OYSTER CREEK NUCLEAR GENERATING STATION
PROVISIONAL OPERATING LICENSE NO. DPR-16
DOCKET NO. 50-219
TECHNICAL SPECIFICATION CHANGE REQUEST NO. 120

Summary of Tech. Spec. Change Request No. 120

FIGURE 6.22
ONSITE ORGANIZATION

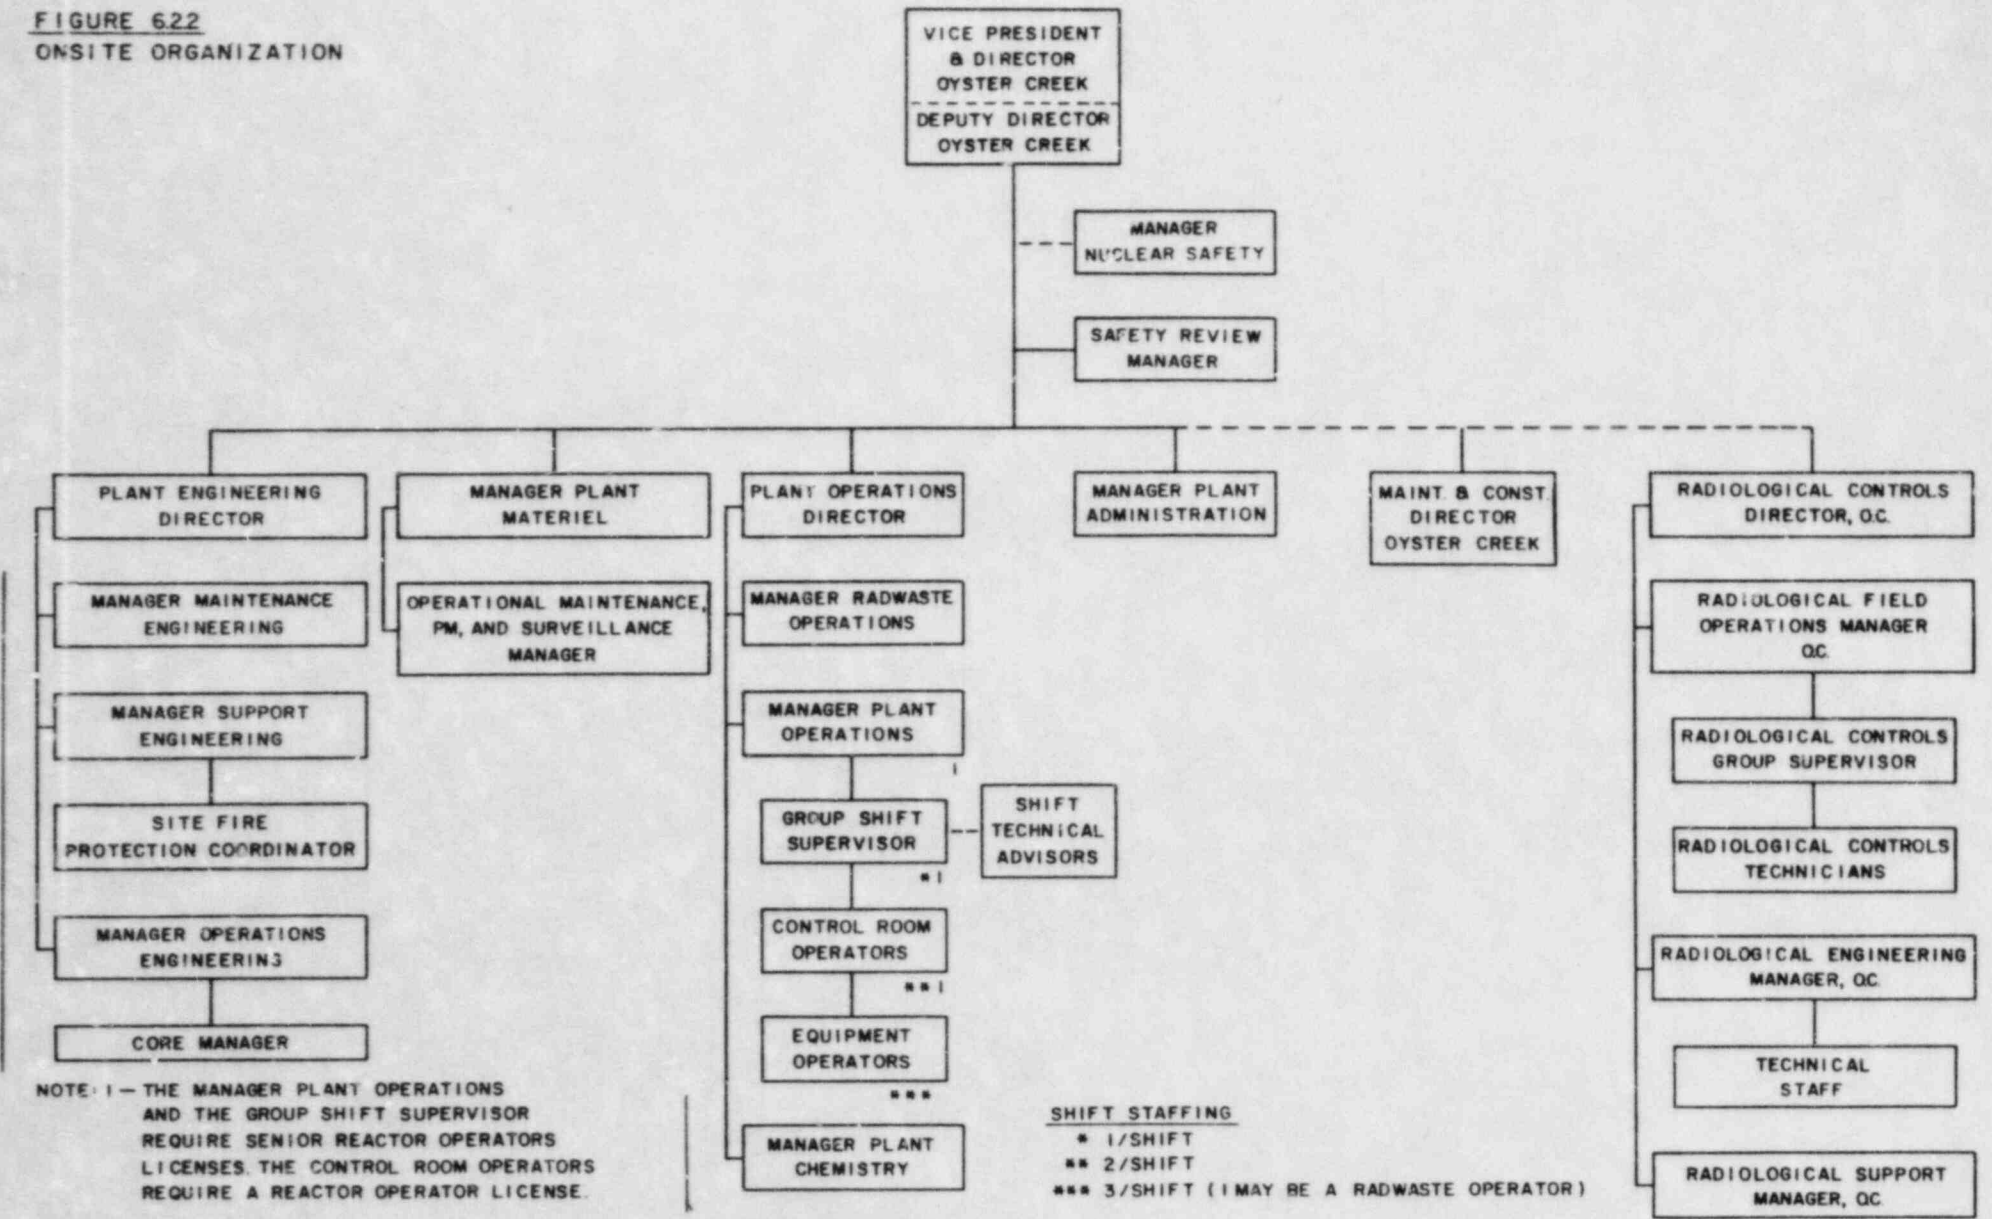
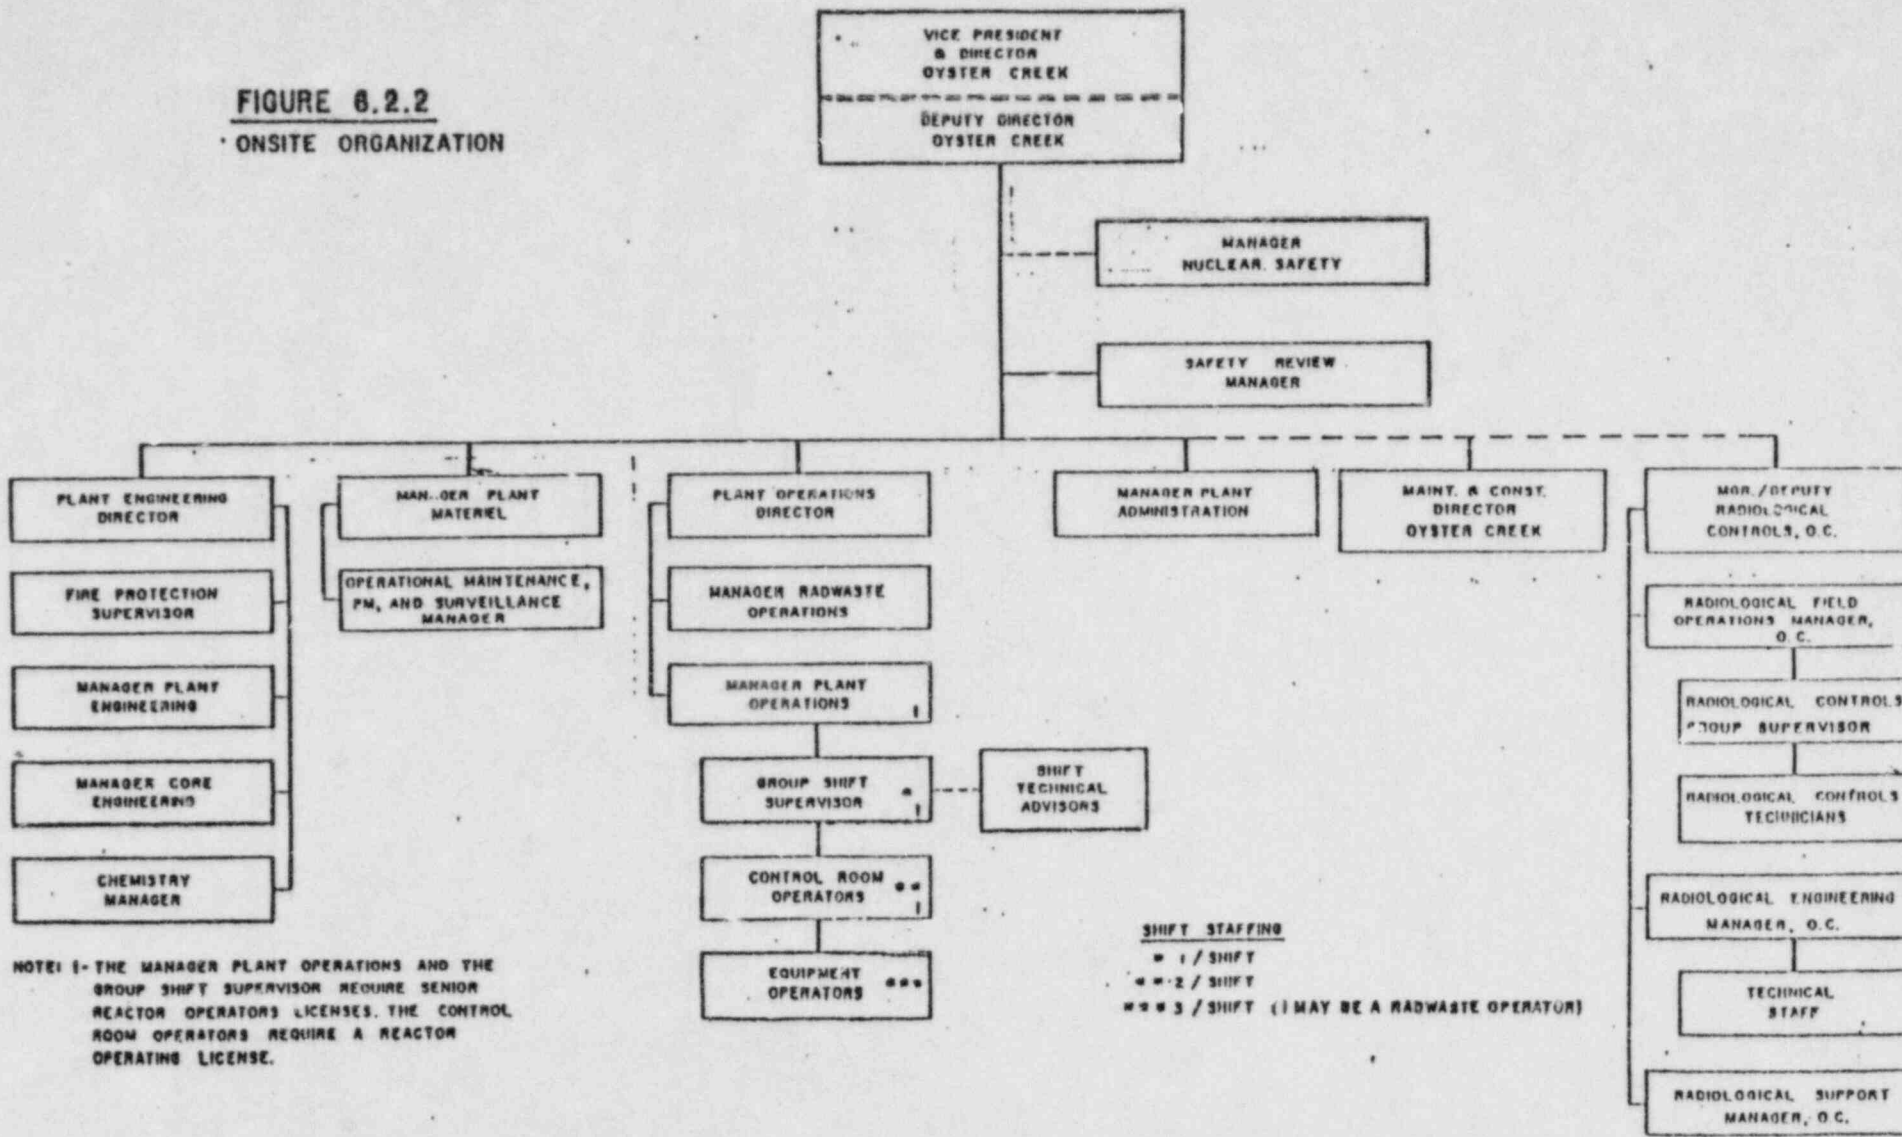
The primary reason for this change request is to submit a Plant Engineering organization which is more responsive to the continuing operations and maintenance needs of the Oyster Creek Facility and to enhance the administrative capabilities of the organization.

- a. Reducing the number of direct interfaces to both the Plant Engineering Director and the Manager - Plant Engineering.
- b. Provide a three Manager structure with specific responsibilities in the areas of Operations, Maintenance, and Support.
- c. Provide direct interfaces with Plant Engineering for the related organizations of the Oyster Creek division and GPUN.
- d. Assigning specific responsibility to a dedicated group for discharging the administrative functions of Plant Engineering.

<u>No.</u>	<u>Current Tech. Spec.</u>	<u>Proposed Tech Spec.</u>	<u>Extent of Change</u>	<u>Justification</u>
1.	Figure 6.2.2 Page 6-4	Figure 6.2.2 Page 6-4	Figure redrawn to reflect reorganization of Oyster Creek Onsite Organization within Plant Engineering, Plant Operations, and Radiological Controls	GPUN approved administrative change
